PROJECT: Mooresville Selma Burke MS (Louisville VMGS20)
PROJECT NO: 221.083
SUBMITTAL: Submittal 233800-6.0 Kitchen Exhaust Fan Controls
DATE RECEIVED: March 4, 2022

PROJECT: MGSD Middle School 9201-201600 DATE SENT: 3/4/2022
 RETURN BY: 3/11/2022
 SUBJECT: Kitchen Exhaust Fan-Controls SUBMITTAL ID: 233800-6-0
 TYPE: Submittal TRANSMITTAL ID: 00705
 PURPOSE: For Review and Comment VIA: Info Exchange
 SPEC SECTION: 233800

Model: GPF

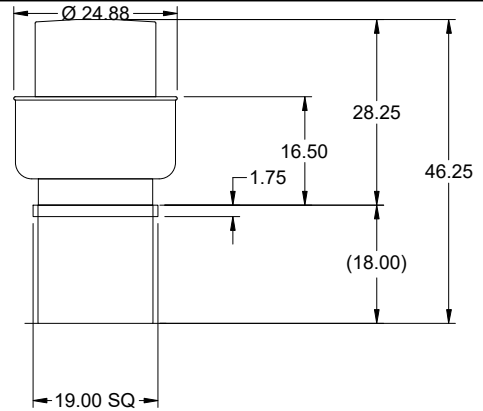
1. *Provide KEF-1 with 16" roof curb as indicated in specifications.*

Spec Section 233800 calls for a 16" curb.
